**COMMISSION FOR
HISTORICAL & ARCHITECTURAL
PRESERVATION**

STAFF REPORT

REQUEST: Construct five new three-story rowhouses

ADDRESSES: 41 & 43 S. Arlington Avenue and 1101, 1103, & 1105 Hollins Street (Union Square Historic District)

Image 14: 1101-1103-1105 Hollins Street, front elevations

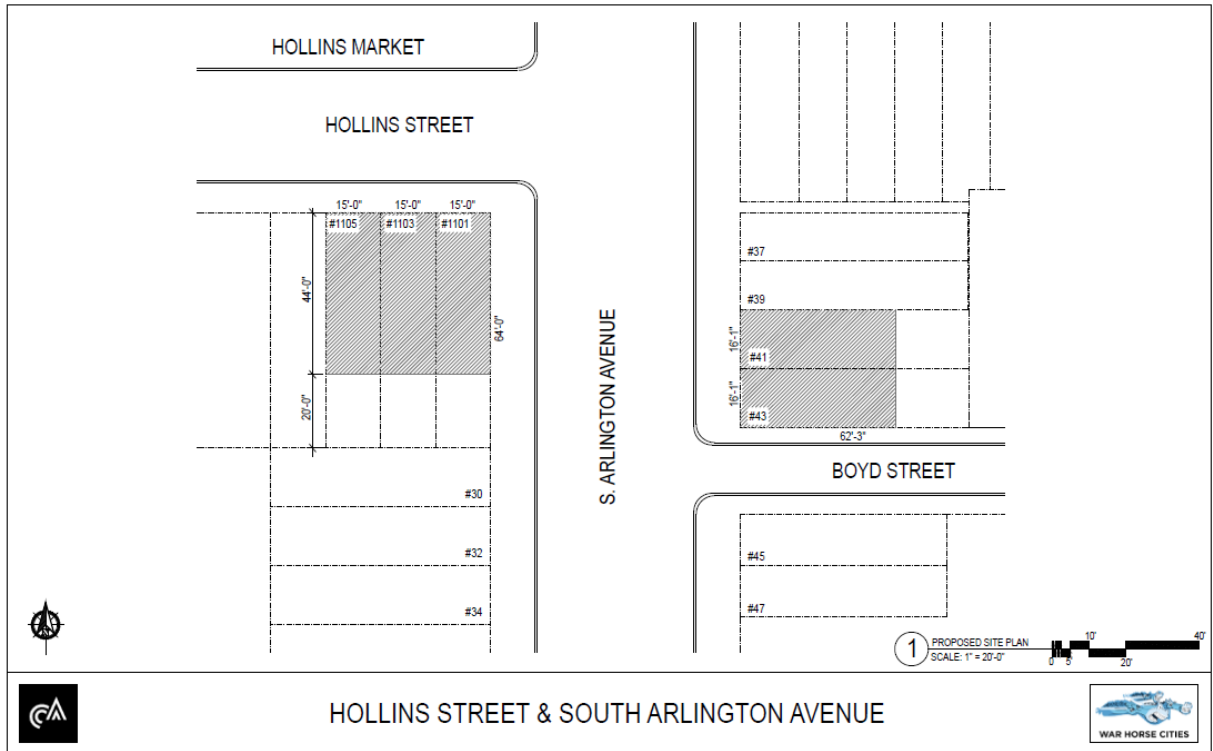
- *2.3 Scale and Form:* The height and depth of the buildings are compatible with the height and depth of other buildings in the neighborhood overall, but the same facades don't work quite as well at both locations. On Arlington Avenue, the new buildings will directly abut two two-and-a-half story historic buildings. On Arlington Avenue in particular, the façade design could relate more effectively to the adjoining historic houses by perhaps lowering the first floor slightly and/or removing the belt courses. The rhythm of the window openings, due to the use of single-paned paired casement window in bays, differs from the neighborhood, and therefore the plans partially meet this guideline.

- *2.4.1 Building Entrances:* The front entrances with glass doors and with stoops are effective connectors to the street, and meet the design guidelines, but the heights of the doors and the transoms don't align with the tops of the windows.

- *2.4.2 Bay Windows:* The plans call for contemporary bay windows at each floor. This does not meet the design guidelines, which state: "Do not design new bay windows in neighborhoods where there is no historic precedent" and "Design new bay windows to be compatible with the length, height, and style of bay windows on surrounding buildings." Bay windows are not a design feature in Union Square rowhouses.

- *2.4.5 Roofs:* The proposed roofs are flat, which are compatible with the designs of surrounding buildings. The roof cornice detail needs to be worked out a bit more to relate to the cornice treatment at the tops of the bay windows. The plans partially meet the design guidelines.

- *2.5.1 Doors and Windows:* The proposed windows are casement windows topped at the first and second floors with varying sized transoms. The transoms seem unnecessary, especially at the upper floors, and they don't align with the other windows or tops of the doorways. The casement windows with large single panes appear as large voids in the facades. The more appropriate treatment would be one-over-one sash windows—which relate to window configurations throughout the neighborhood—and adding sills and lintels. In both locations, the end units—1101 Hollins and 43 S. Arlington—have only two windows, and these are at the first floor. Instead of using masonry detailing to suggest windows on this elevation, the design should include more actual windows, even though this might mean some reconfiguration of the floor plans. At the rear, the casement windows again look like great voids and would more appropriately be one-over-one sash windows. At the first and third floor, there is an unusual positioning of windows directly abutting a door, and the use of tiny windows aligned with no other window or door. The plans do not meet these guidelines.

Staff recommends concept approval of height, scale, and massing, with plans to return to Commission for final approval of design details. Staff recommends that the architect develop more fully:

- Alignment of tops of doors, transoms and windows, with elimination of transoms above first floors
- Relate cornices at top of bays to roof cornices
- An alternative to casement windows, such as one-over-one windows, include more windows at end unit street elevations, and rework window-door placement at rear elevations.
- Some modifications to facades, specific to 41, 43 S. Arlington Avenue plans, to relate more effectively to adjoining historic houses, such as lowering first floor slightly and/or removing belt courses.
